REMARKS/ARGUMENTS

4B ← FIG. 4A

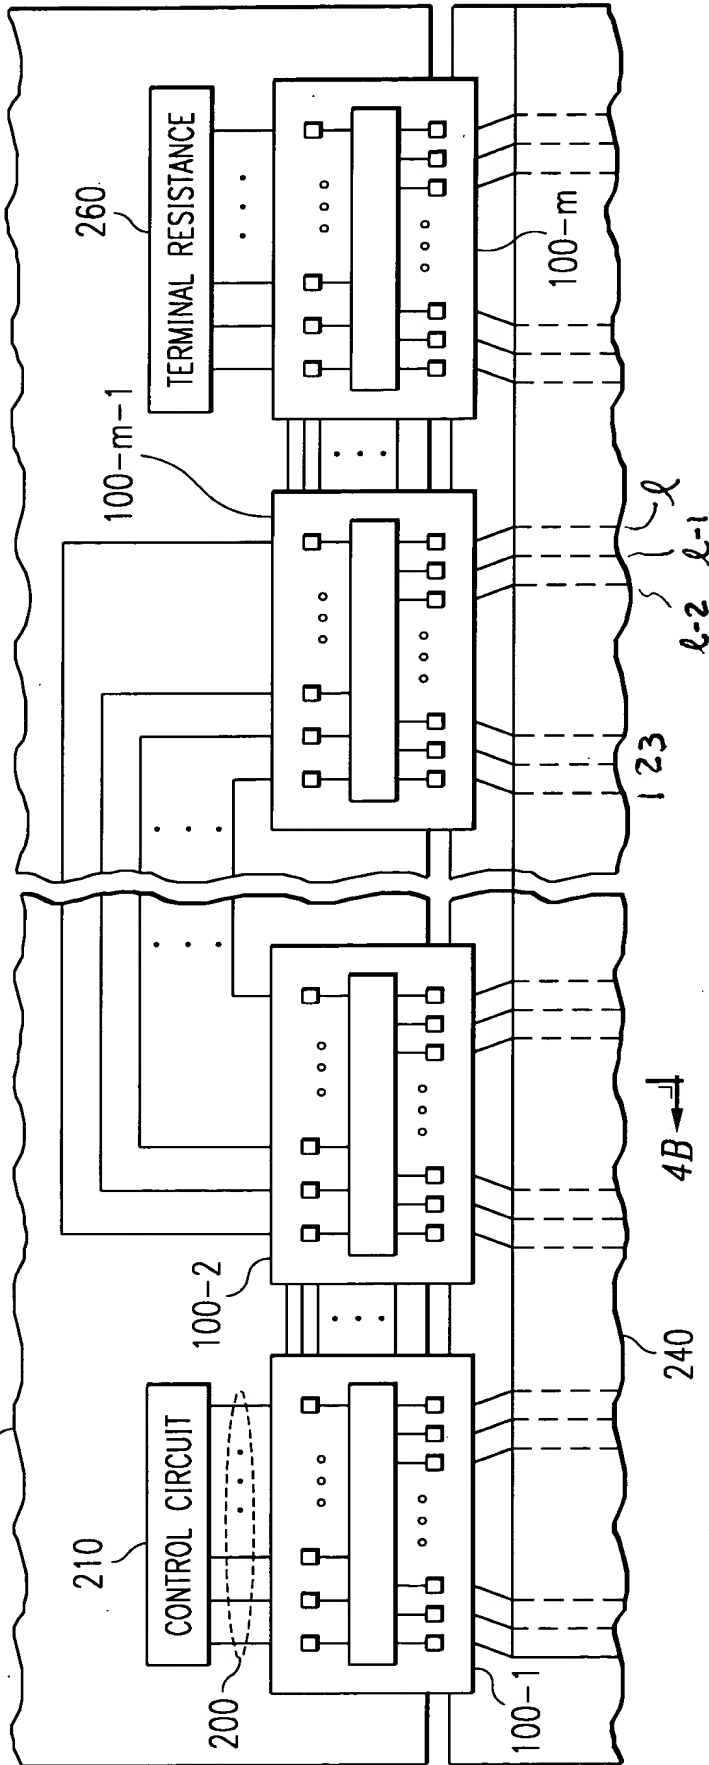
The Examiner objects to the drawings under 37 C.F.R. 1.83(a) in that the drawings must show every feature of the invention specified in the claims. The Examiner states that therefore that the m output signals must be shown on the features canceled from the claims. The Examiner notes that m in the original application is associated with the LCD driver ICs from 1 to m. The Examiner requires a proposed drawing correction in reply to this Official Action.

In order to avoid confusion between the number of output signals and the number of integrated circuits, Applicants have amended Claim 11 by replacing "m" with --l--. In addition, Applicants have amended Figure 4A by labeling some of the unlabeled outputs from the integrated circuit 100-m-1 as 1, 2, 3...l-2, l-1 and l_j. Thus conforming with the recitation in Claim 11. In view of the fact that these outputs existed in Figure 4A, as filed, and all Applicants did was label them in conformance with Claim 11, no new matter has been entered.
